# Requests for information – Minor Applications

## 1.4 Rettenmaier, 4 Childe St. CP17-009

PROJECT NAME  
BELONGIL SEAWALL REPAIRS

CS6-UW-002 (Rev a)

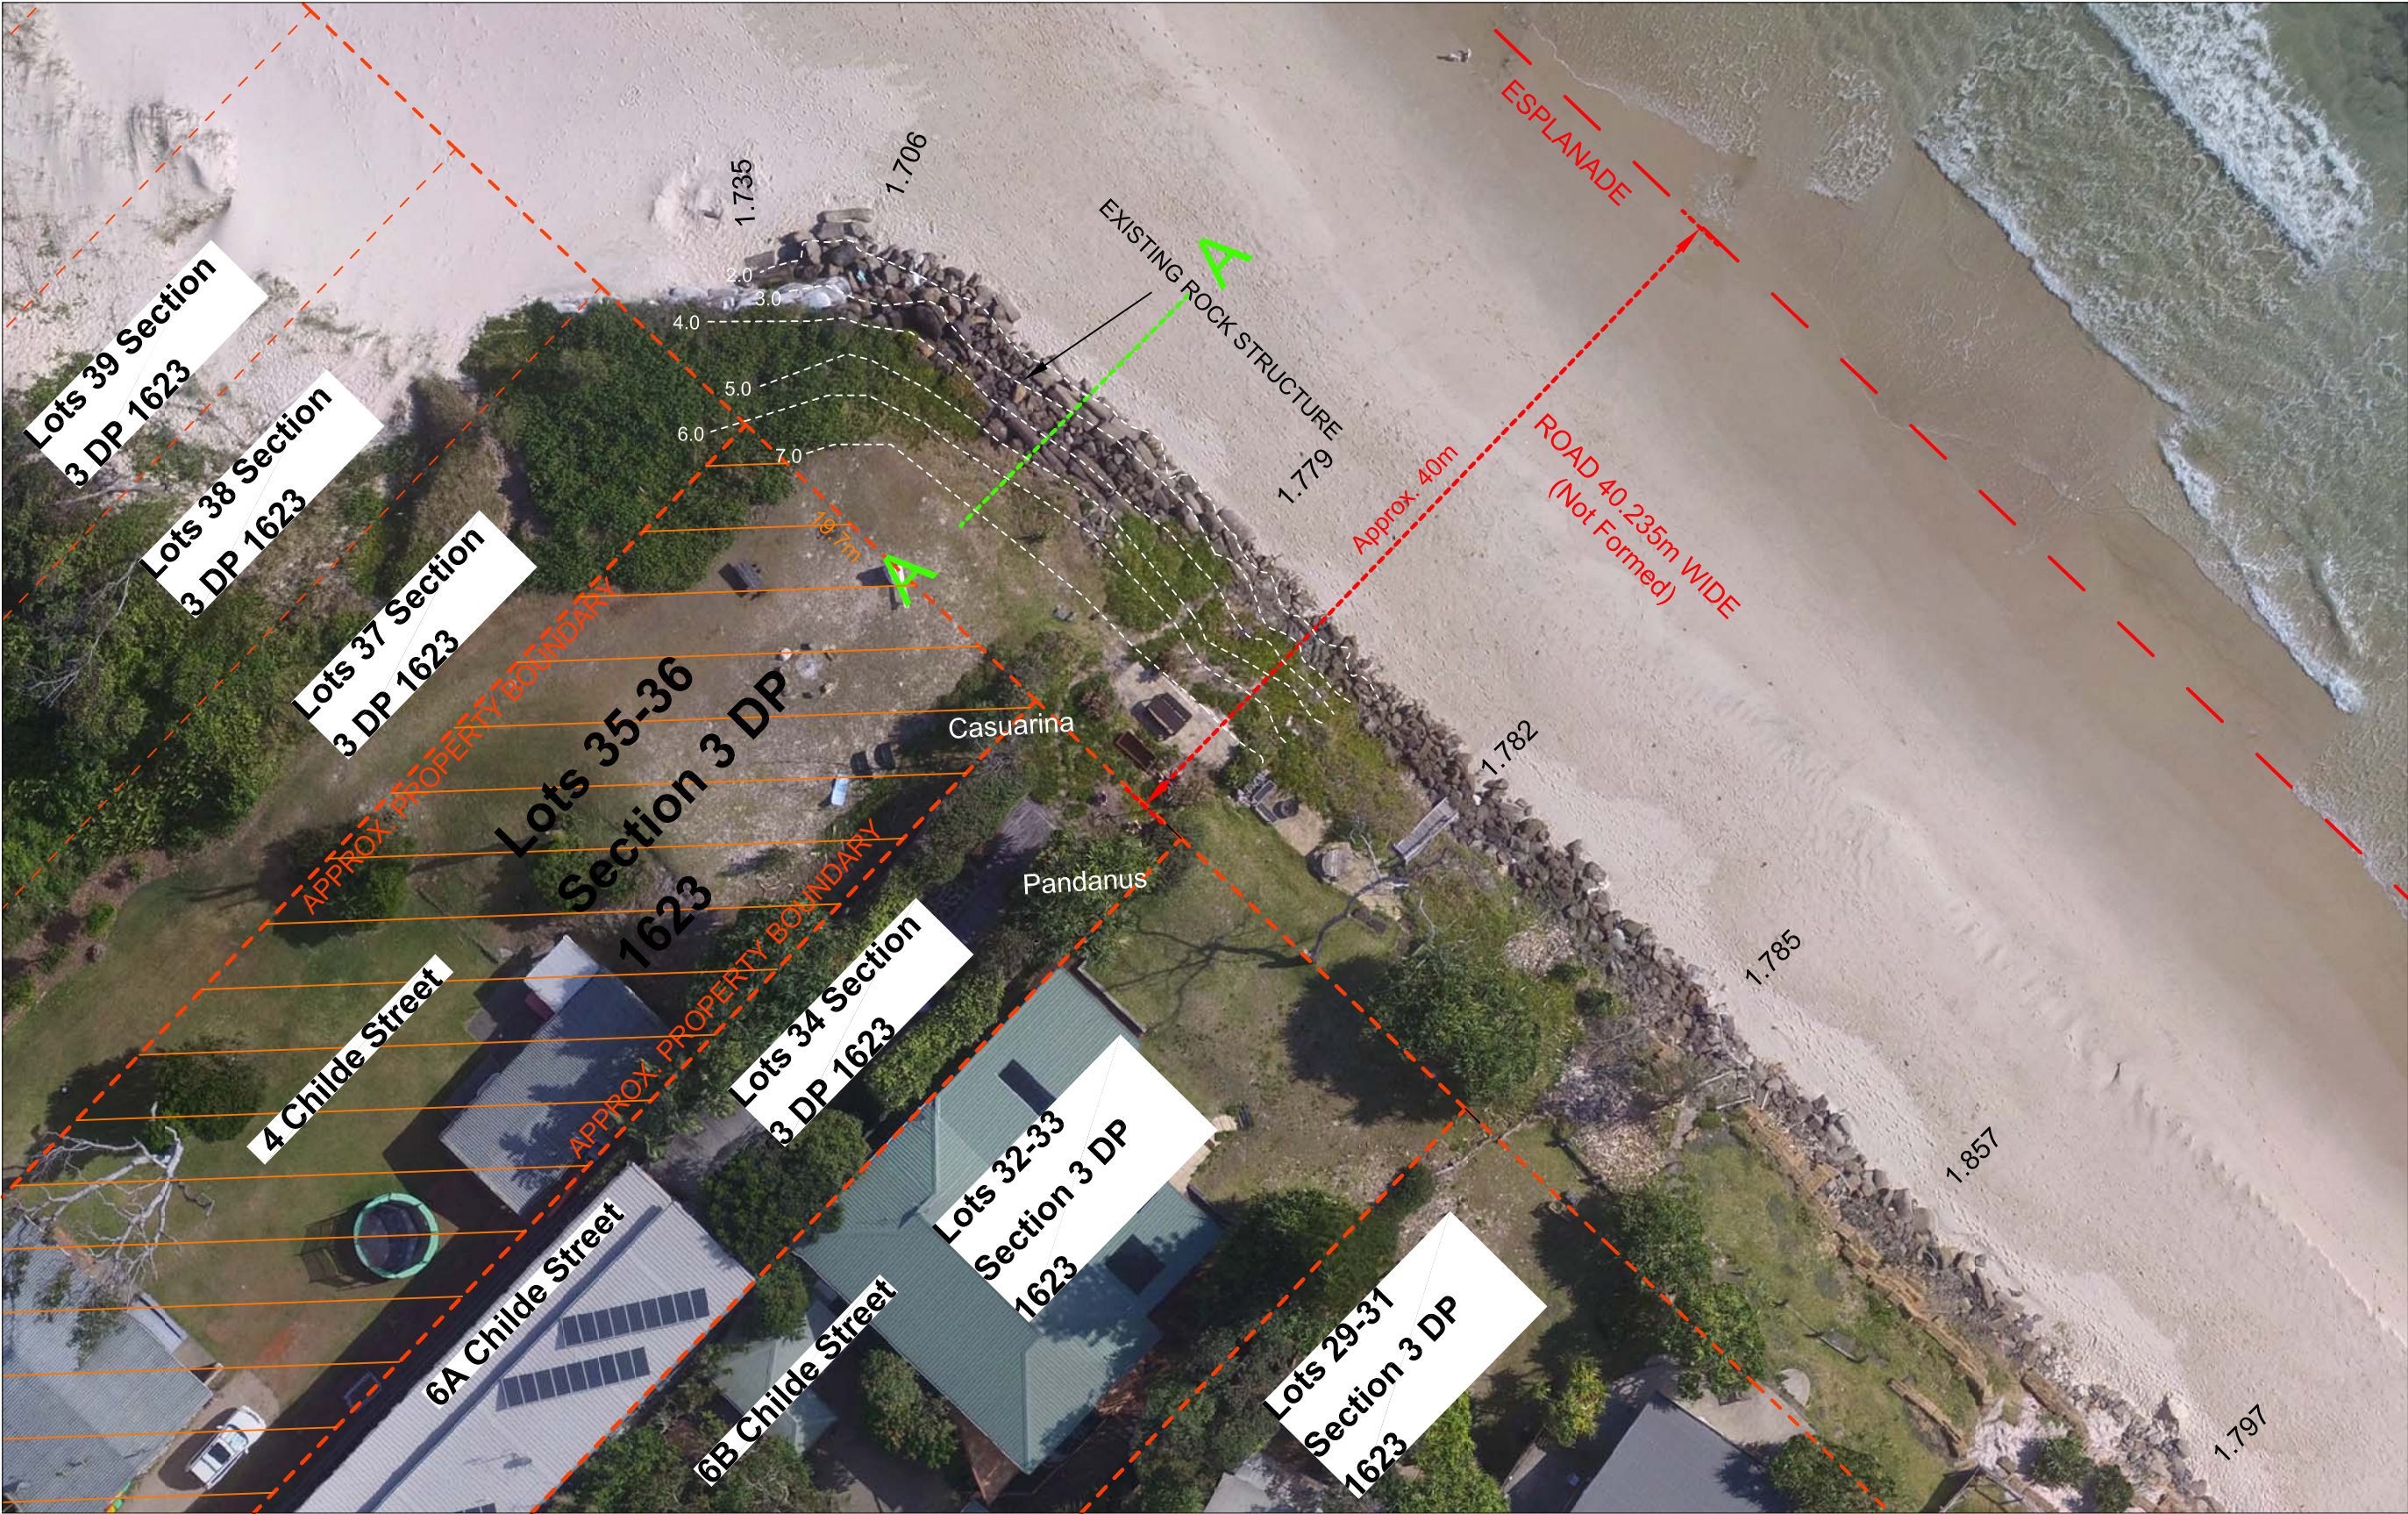
#	Request for information	Response
1.	A current survey indicating the heights of the current structure (the face of the wall "as is"), property boundaries, footprint of the proposed works and the current sand level	<p><b>We have already provided this information.</b> The details requested have been provided in the technical drawings previously provided:</p> <ul style="list-style-type: none"> <li>• height of current structure and face of wall: Drawing BSR-CS6-UW-003 shows these details. ICM have also added contours of the visible section of the seawall face of the wall in drawing BSR-CS6-UW-002 (Rev a - Attachment 1.4 A). Please note that these contours are smoothed in the drawing as the wall face is very rough with 20-30% voids between large boulders.</li> <li>• property boundaries: Drawing BSR-CS6-UW-002 and 003 show these details. The seaward boundary and corners will be pegged before repairs are commenced.</li> <li>• footprint of the proposed works: BSR-CS6-UW-005</li> <li>• existing sand level: BSR-CS6-UW-002 &amp; 003 show beach sand levels at the wall as at 13/10/16 (post June 2016 storms) and there has been a slight increase in sand (about 0.5m) since that date to 17/1/18.</li> </ul>

1999 Design Drawing - signed

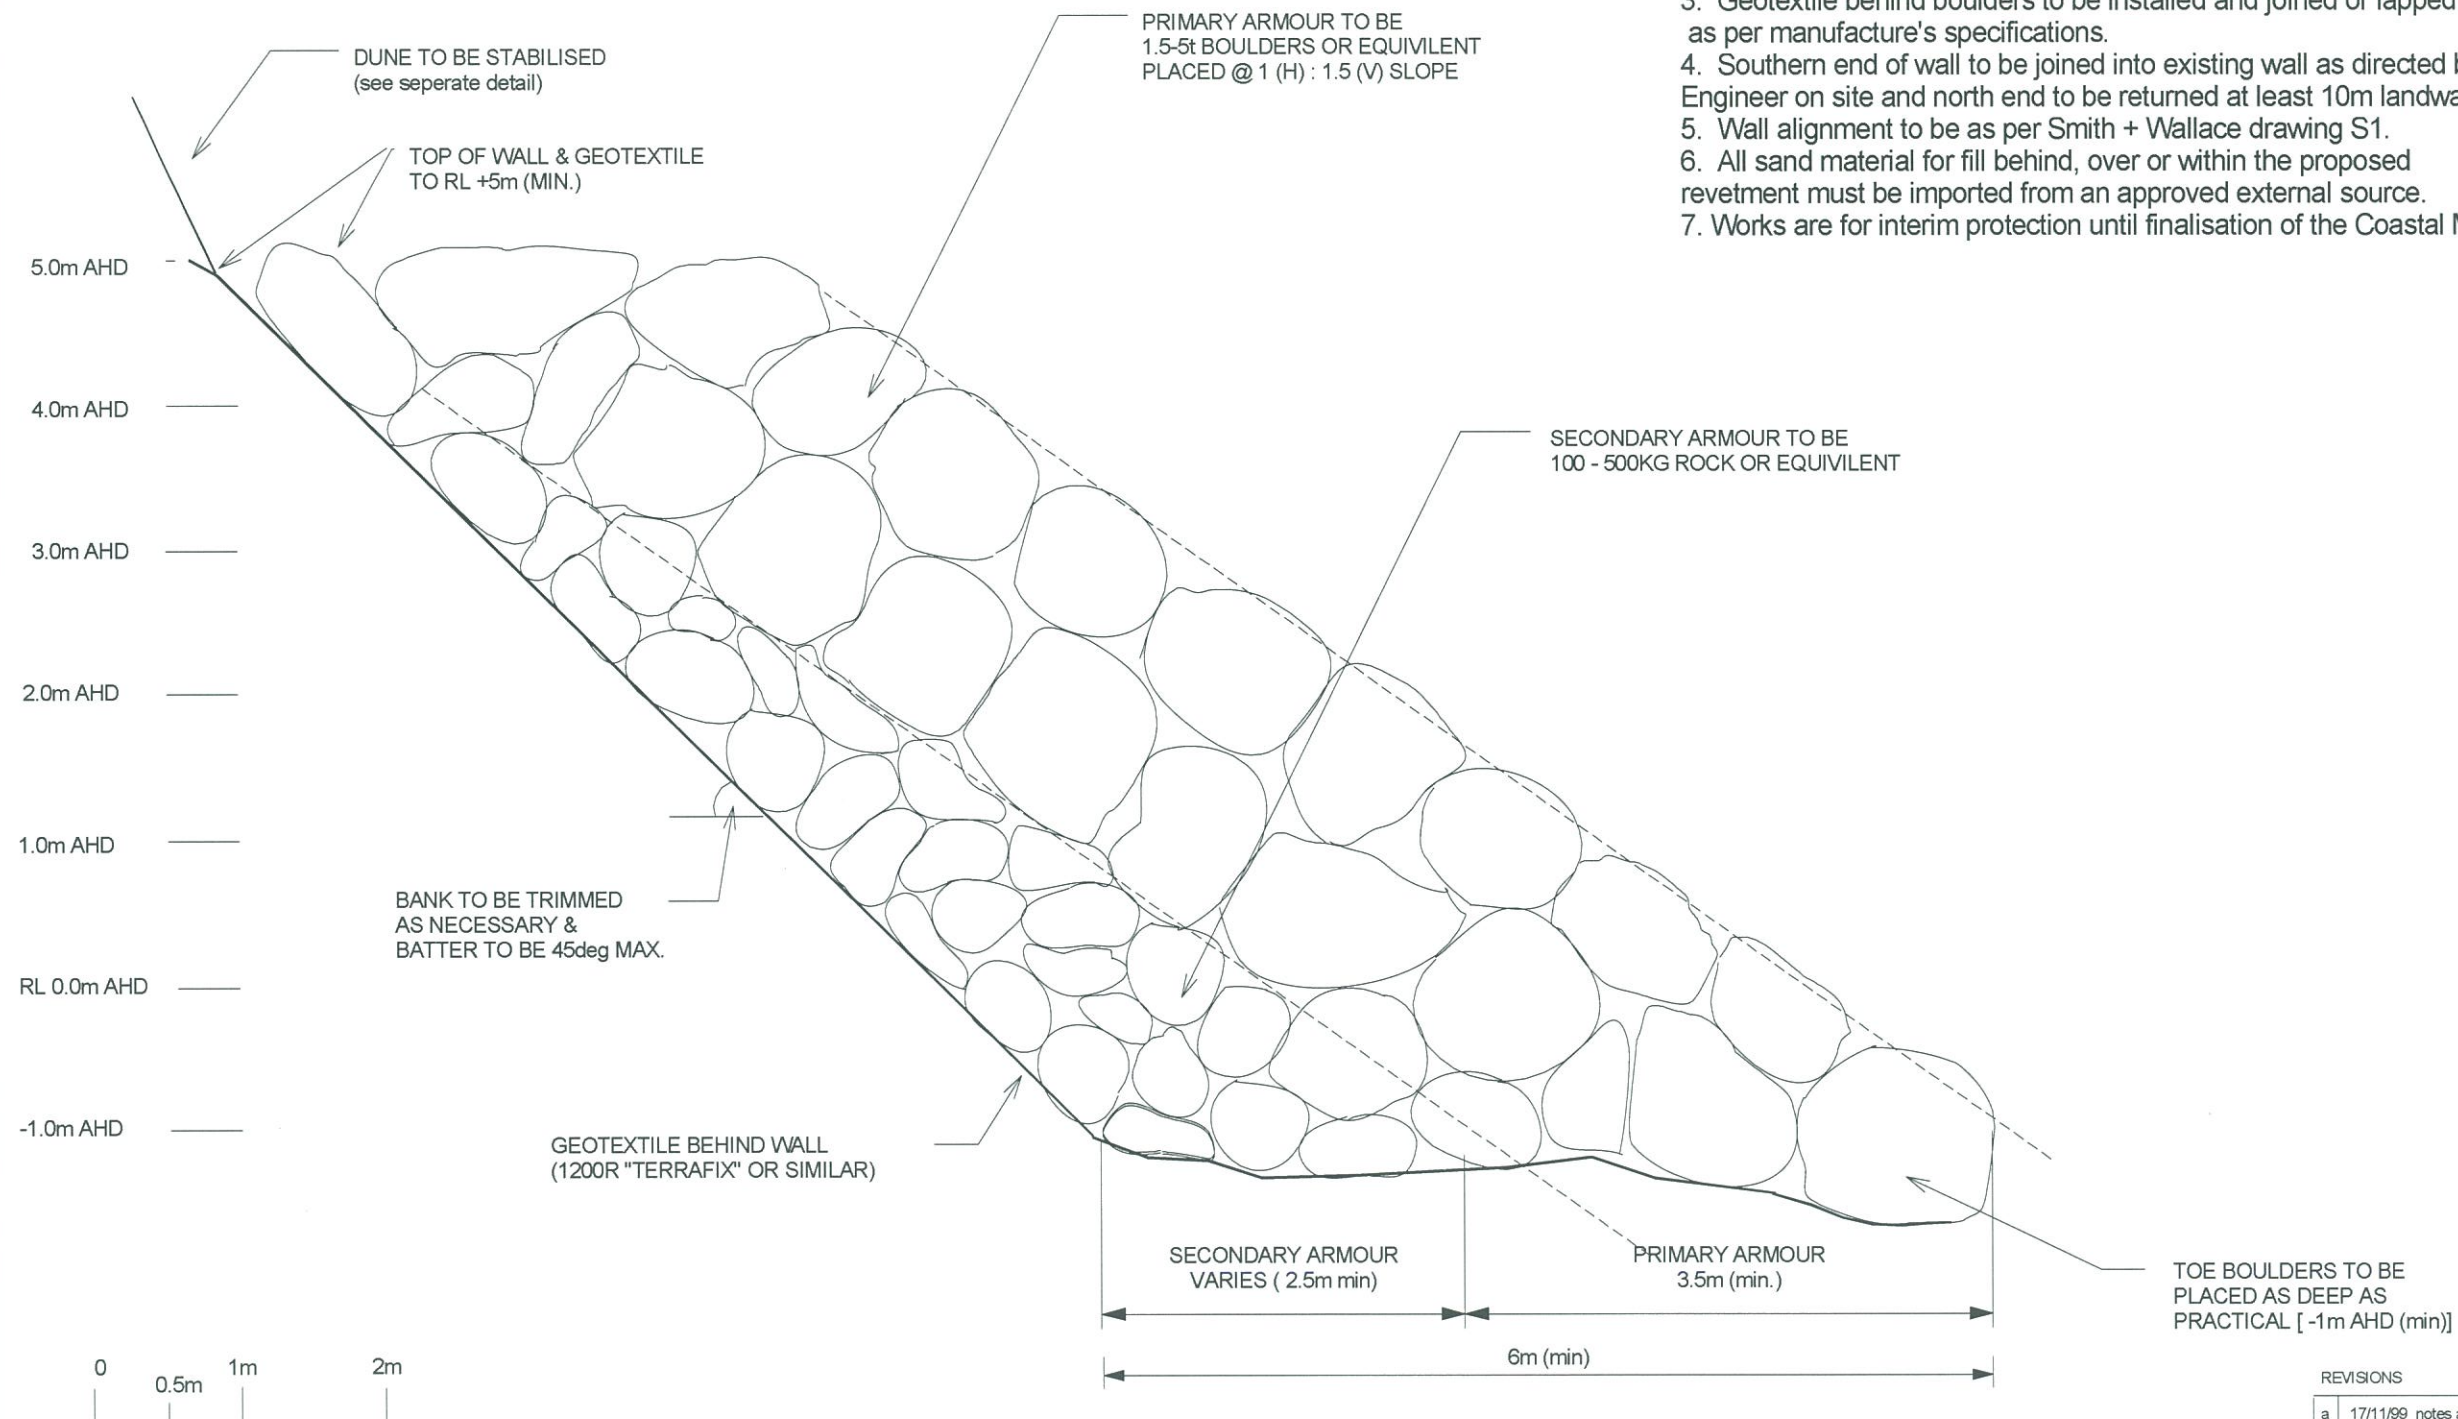
8.	<p>Please provide</p> <p>a. a full (signed and dated) copy of the design and "as constructed" drawings for the 1999 works; and</p> <p>b. a legible and dated A3 copy of the "Canty survey" provided in the DA materials.</p>	<p>a. <b>We have already provided you with a copy.</b> A signed copy of this design is attached as Attachment 1.4 B</p> <p>b. BSR-CS6-UW-007 has been attached to show the Canty survey more clearly. (Rev a - Attachment 1.4 C)</p>

4.	Grading and specifications of the existing layer of primary armour stone	<p><b>As per previous advice</b> (ICM Report August 2017 Section 3), the wall was constructed with sound (unfractured) primary armour with 50% of the rocks in the primary layer to be greater than the average of the weight range specified (1.5-5t). As per previous advice (ICM Report August 2017 Section 3), the wall is substantially</p>
